**CORRESPONDENCE COVER SHEET
WASTE PERMITS DIVISION
TEXAS COMMISSION ON ENVIRONMENTAL QUALITY**

Date: May 17, 2019
 Facility Name: City of Kingsville Landfill
 Permit or Registration No.: MSW 235-C

Re: City of Kingsville Landfill – Kleberg County
Municipal Solid Waste (MSW) - Permit No. 235C
Permit Amendment Application – Supplemental Information
Tracking No. 23301130, 23458984, and 24040819; RN102334570/CN600674246

On behalf of the City of Kingsville and in response to your May 10, 2019 and May 16, 2019 email requesting supplemental information, we hereby submit the enclosed response regarding the Permit Amendment Application for the above referenced MSW facility.

MAY 15, 2019 4:55 PM TORRE01809 I:\16\JOBS\16L0438B\CAD\SITE\SHEET\NOD-SUPPLEMENTARY\FINAL\PART III\8514-03-EXH3-X-SECTS-SOIL-BORING-REPORT.DWG

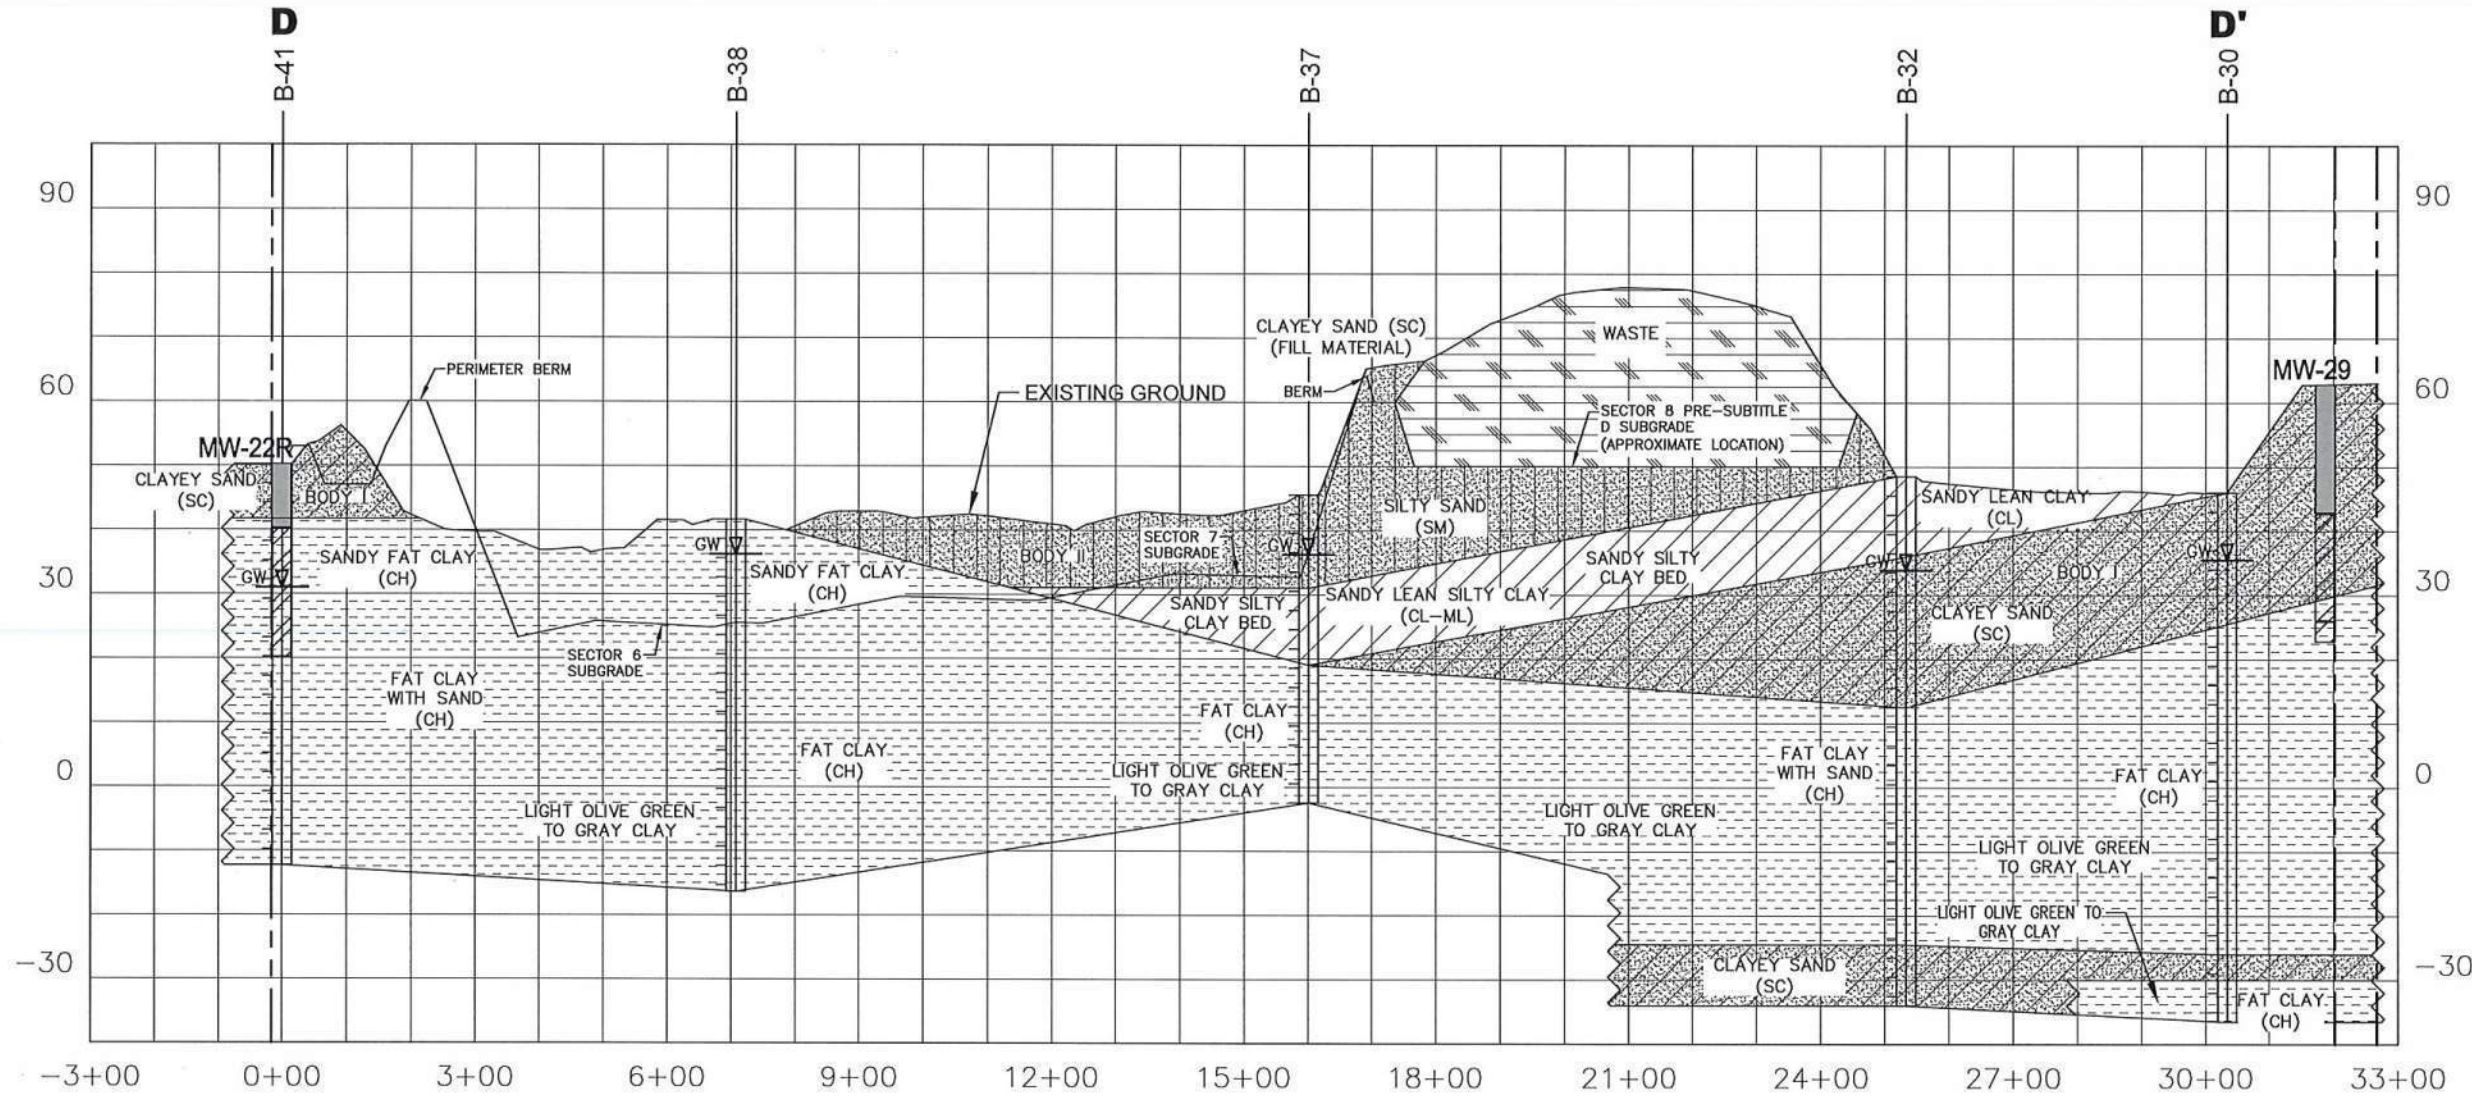
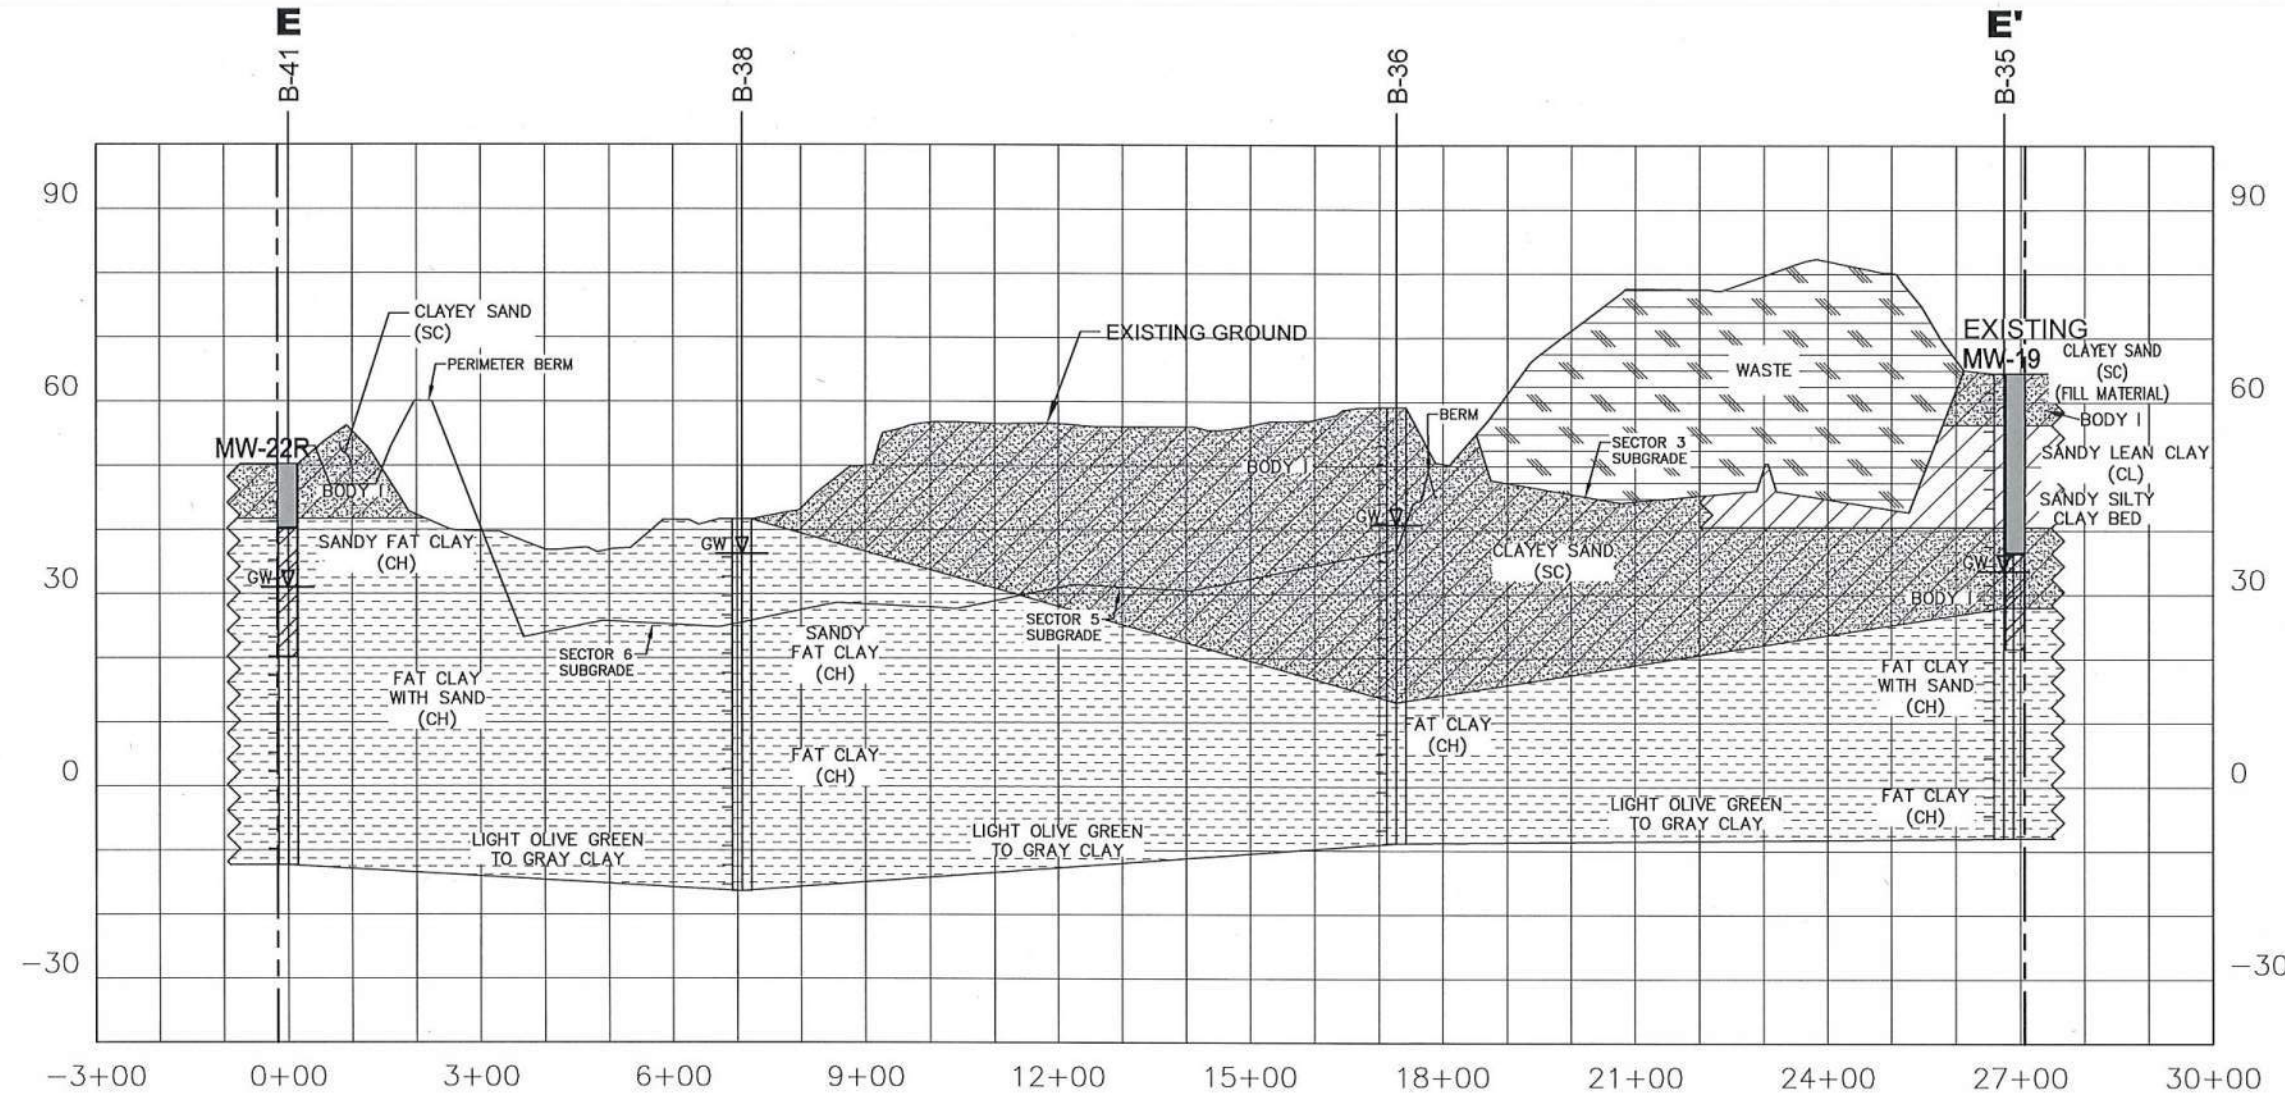
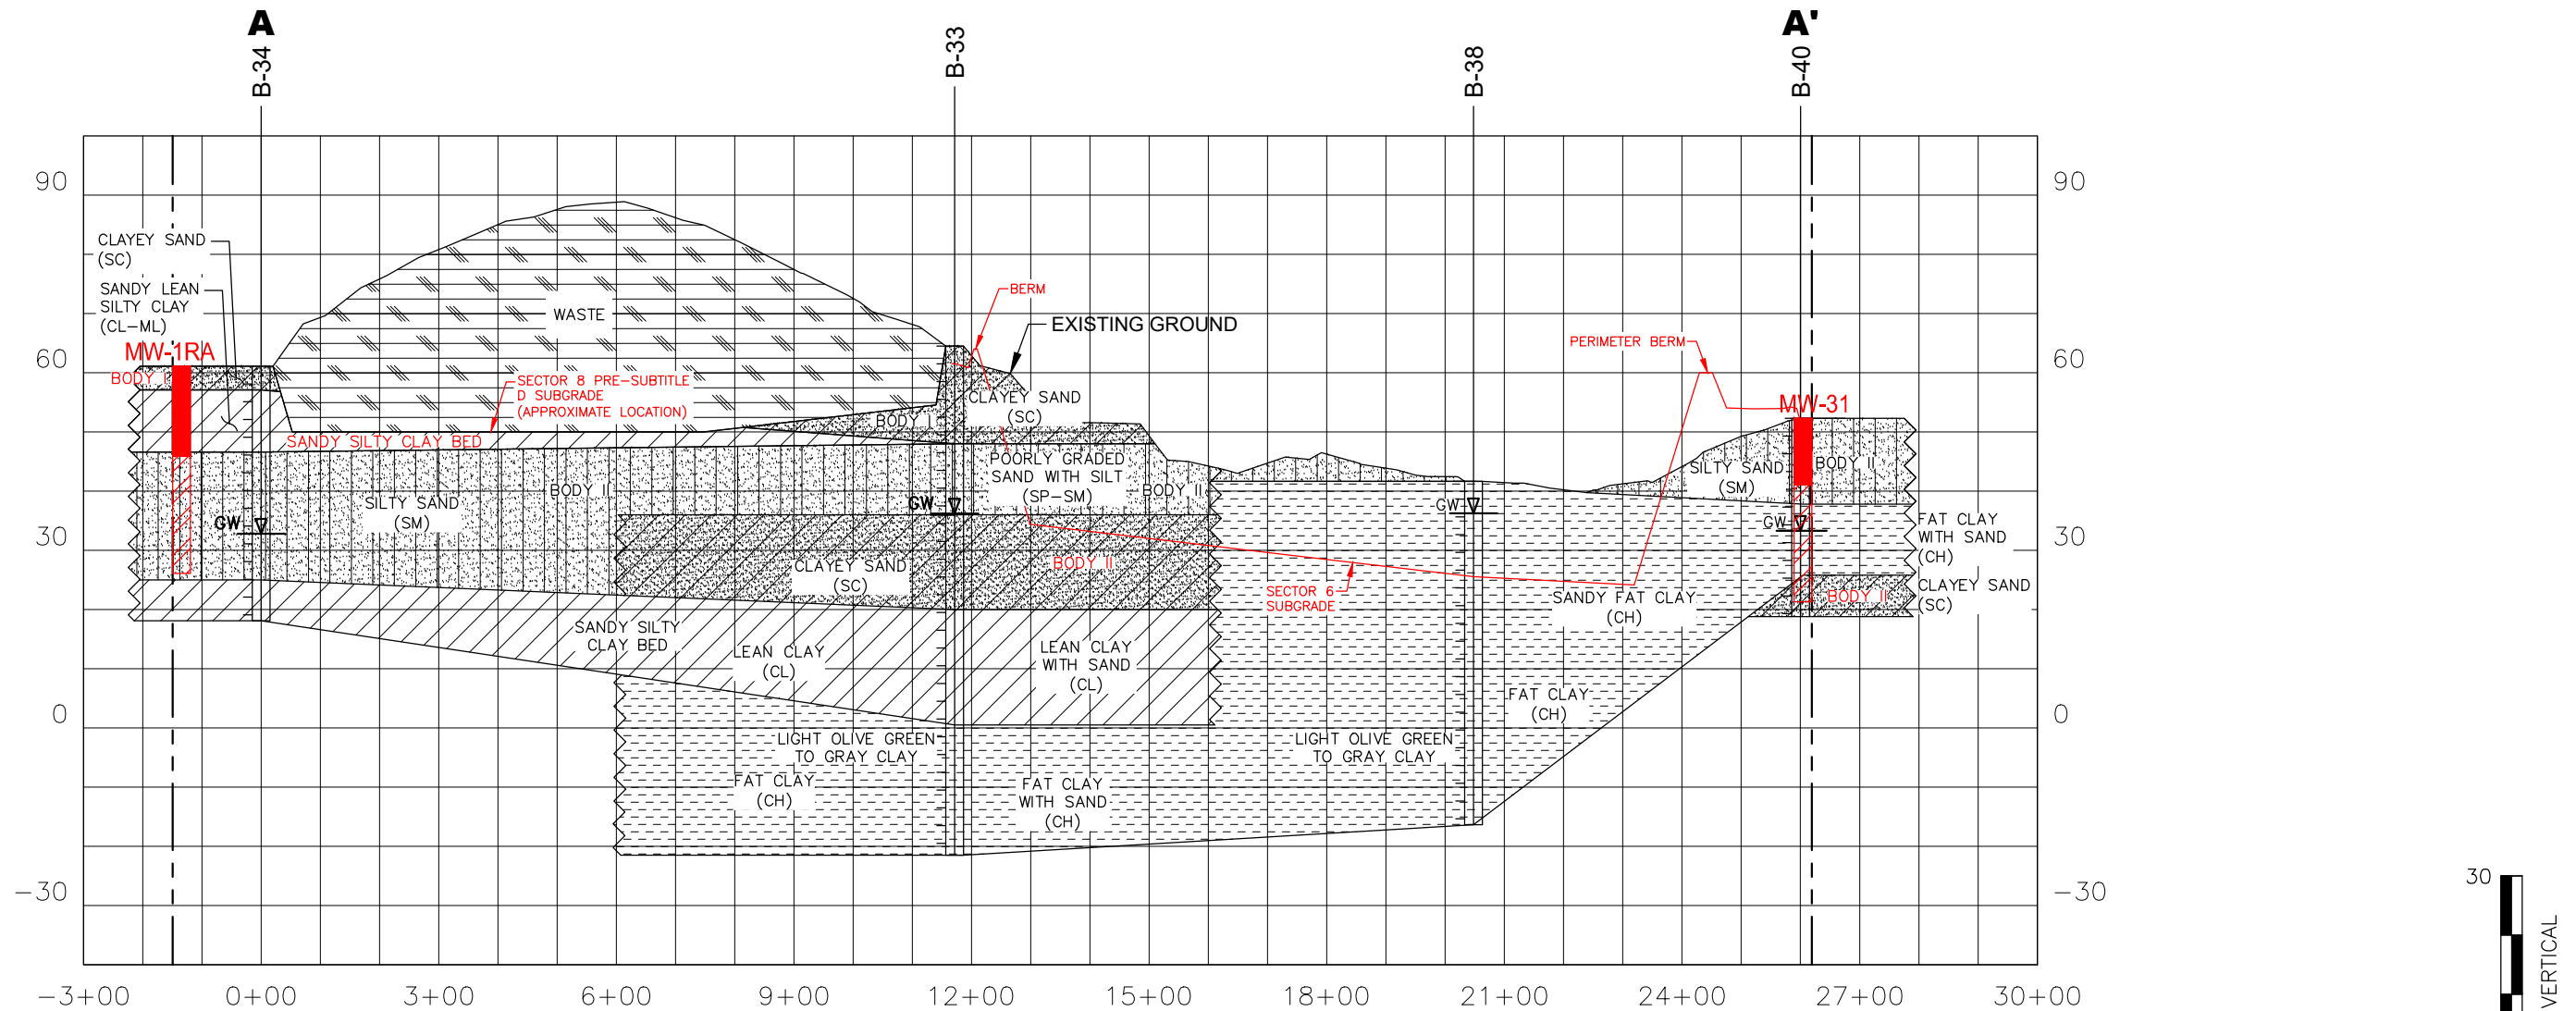
ID	Checklist Item	Citation
496	Submit cross-sections prepared from the borings; depicting the generalized strata at the facility. For small waste management units, two perpendicular cross-sections will normally suffice	330.63(e)(4)(G)
Location		NOD Type
Att 4, App 1, Sec 6.2.2, p. 64-79		Incomplete
NOD Description		
Revise the Hanson cross sections in Att 4 to show existing and proposed groundwater monitor wells that are on or close enough to the lines to show on cross sections; include screened intervals. Also show existing and future landfill base grades.

The Hanson cross sections in Attachment 4 have been revised to show existing and proposed groundwater monitor wells that are on or close enough to the lines to show on cross sections; screened intervals have been included. Existing and future landfill base grades have also been added.
